UNITED STATES PATENT AND TRADEMARK OFFICE

APPLICATION NO.	FILING DATE	FIRST NAMED INVENTOR	ATTORNEY DOCKET NO.	CONFIRMATION NO.
09/719,323	01/04/2001	Toshikazu Ura	F-6768	7228

Office Action Summary

DETAILED ACTION

Sept. 25, 1973 JEAN-PIERRE CAILLEY 3,761,314
HIGH DISCHARGE RATE ELECTRIC CELLS AND BATTERIES
Filed June 22, 1971 3 Sheets-Sheet 1

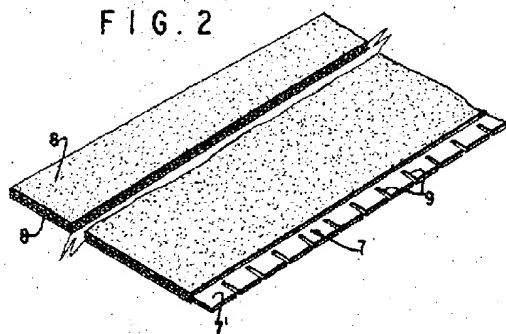
As admitted by the applicant on page 15, lines 1-5 of the specification, folding may occur to some extent using the method depicted in Figure 2. Since there is no mention of slits being made at the edge of the current collector, the folding of the edge of the current collector into a plane will not result in a contiguous flattened spiral region with approximately a flat plane extending orthogonally to the spiral axis. Furthermore, folding of the edge onto itself may result in a discontinuous flattened spiral region. The edge of the current collector must be slit in order to form a contiguous flattened spiral edge with an approximately flat plane as disclosed by Jean-Pierre Cailley in Figures 2 and 3 and reproduced below (US 3,761,314).
